CITY OF YPSILANTI
Agenda
Historic District Commission
Tuesday, December 8, 2020 - 7:00 p.m.
Remote Meeting via Zoom

1. 214 N Grove	New windows and siding
2. 322 E Forest	New garage
3. 301 W Michigan	Small cell communication
4. 401 N Adams (302 W Cross)	Small cell communication
5. 293 Olive (430 N Adams)	Small cell communication

LINE	MARK UNIT	PRODUCT LINE	ITEM	QTY
1	101 frt living room	Infinity	Double Hung	1
2	102 frt living room	Infinity	Double Hung	1
3	103 frt Bedroom	Infinity	Double Hung	1
4	104 side bedroom frt	Infinity	Casement	1
5	105 side bath	Infinity	Casement	1

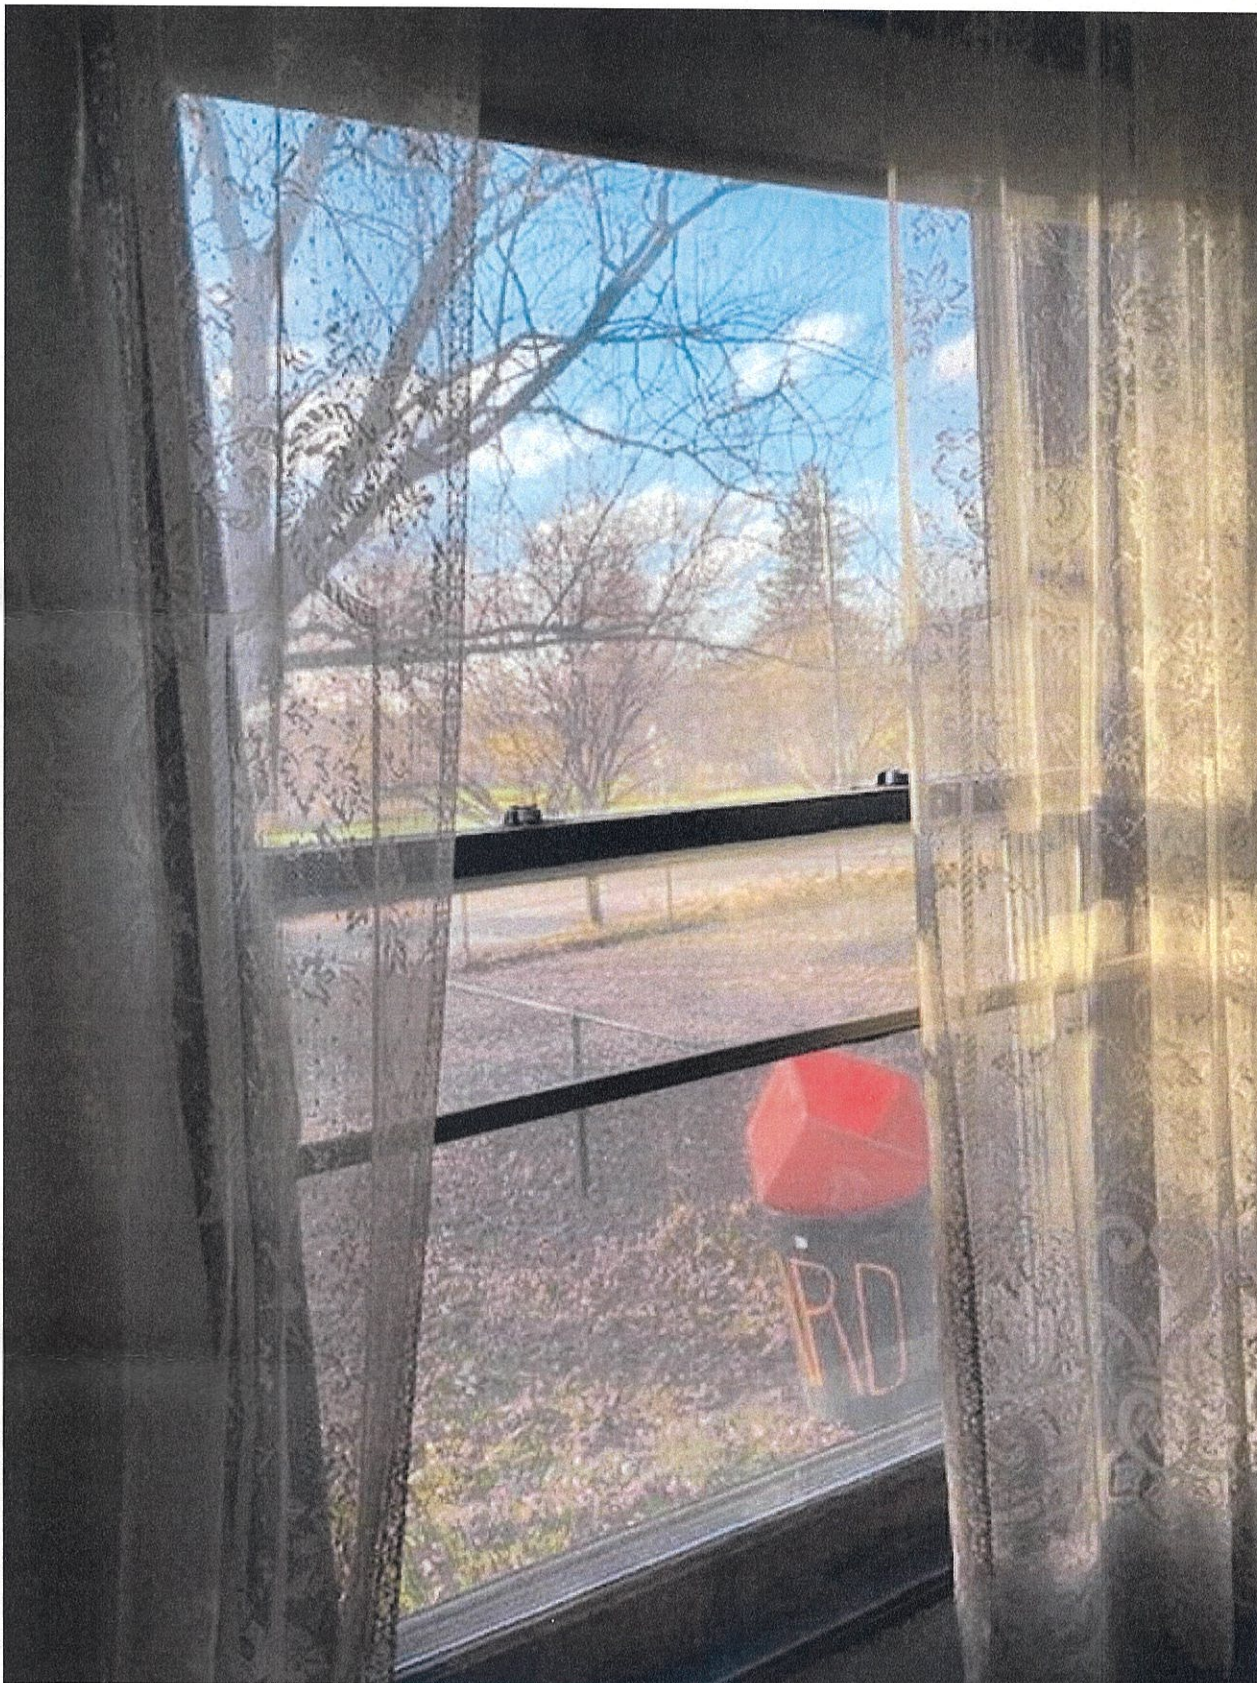
3. The owner proposes replacing these three windows with Ultrex double-hung fiberglass windows.
4. *The sample window in the application is to show materiality, it is not a direct representation of what is proposed. The new windows will match the current windows and not have divided lights.

5. The north elevation windows include two non-historic aluminum-framed horizontal sliders.
 - a. The owner notes weatherization as a key motivation for replacing these windows and states they are of poor quality.
6. The applicant proposes to replace each with a Ultrex fiberglass single-light casement window.
7. The owner said they would consider a dual casement to match the current light pattern, however they would prefer a single light so the windows are large enough to escape from in case of fire.

Move to approve and issue a Certificate of appropriateness for the work at 214 N Grove as submitted in the application dated November 30, 2020 for replacement of five windows with Ultrex fiberglass windows, and new façade siding, as specified. Replacement windows are to be full-frame units and match the size of the windows they are replacing and include three double-hung windows on the façade and two casements on the north elevation. Façade siding shall be HardiPlank lap siding with 6" reveal and a smooth finish, in white.

Left: Foundation Side View.

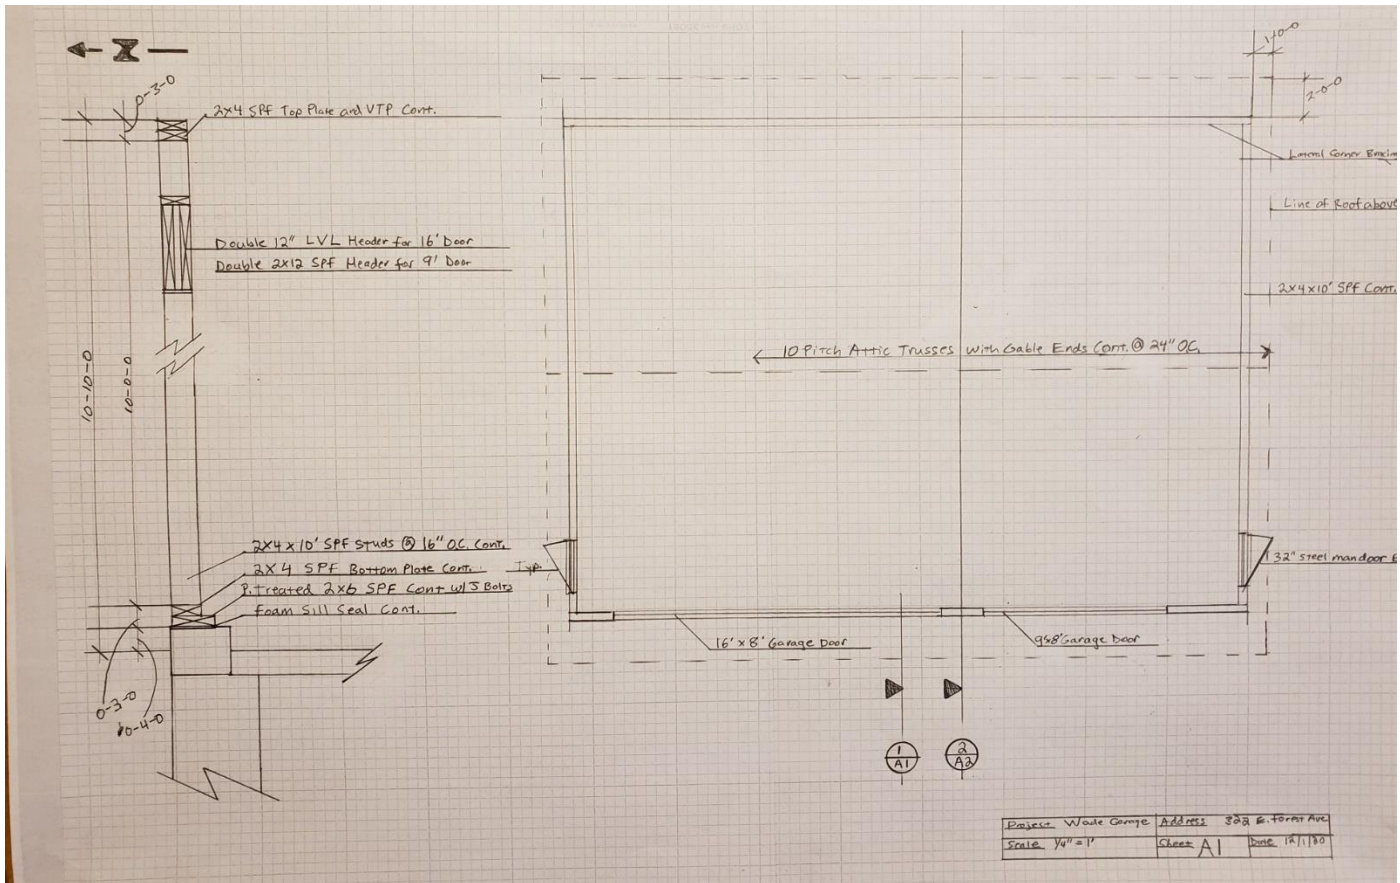
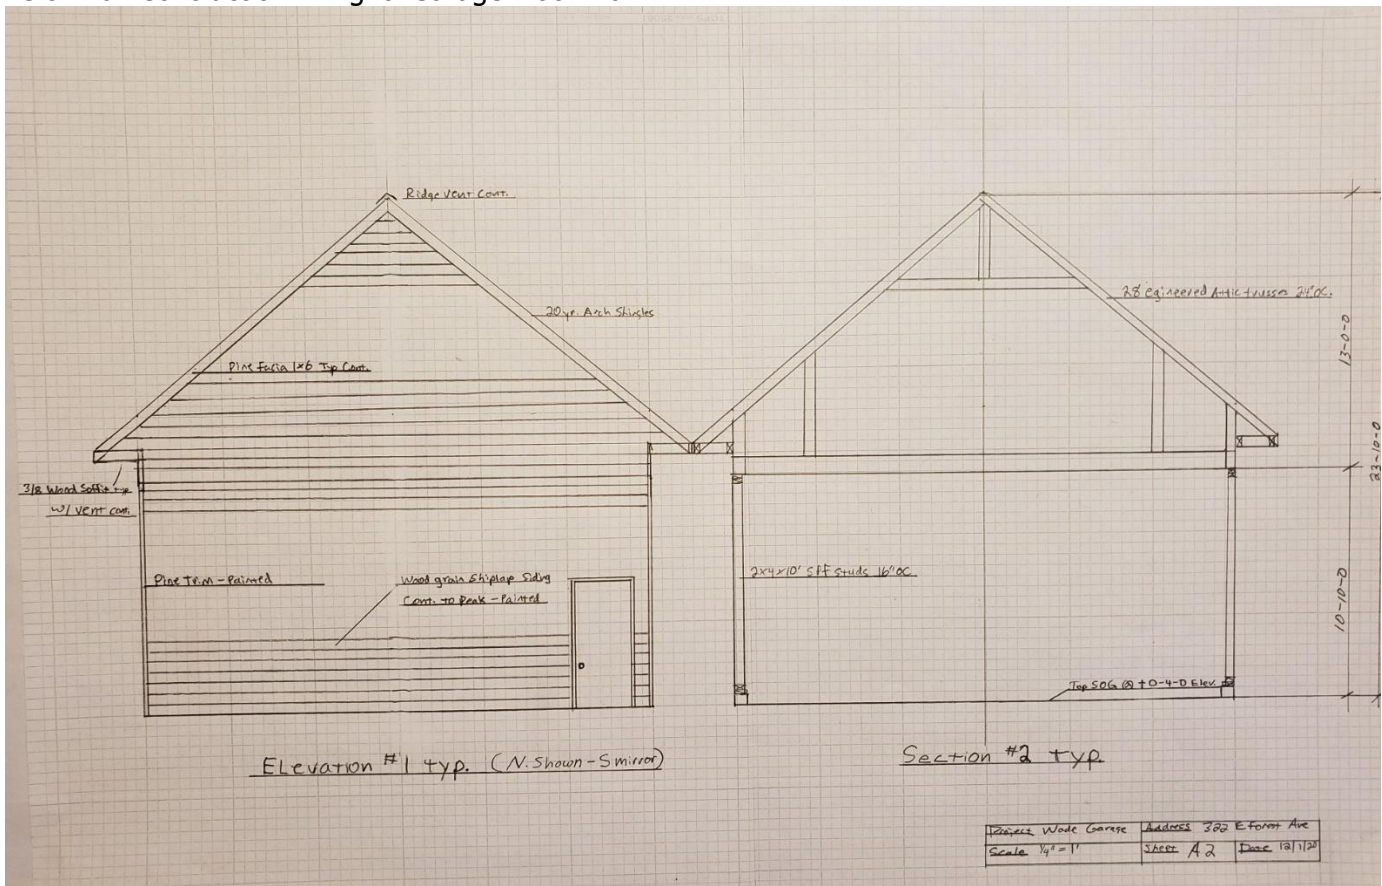
1. The applicant first presented this project as a Study Item on 11/24/2020.
 - a. The applicant took feedback from the Commission and modified the original design.
2. The applicant proposes constructing a one-story garage behind the house and shed, fronting on the public alley that abuts the west property boundary.
3. The garage footprint will be 24' by 33,' and reach a full height of 23'-10" from foundation to ridge.
4. The structure will rest on concrete footings and a concrete pad will be poured for the garage floor.
5. The exterior walls will be clad in HardieBoard lap siding with a smooth finish. (although the drawings say shiplap, the applicant has subsequently decided on HardieBoard).
6. The gable roof will be sheathed in an architectural shingle to match the color of the house (brown).
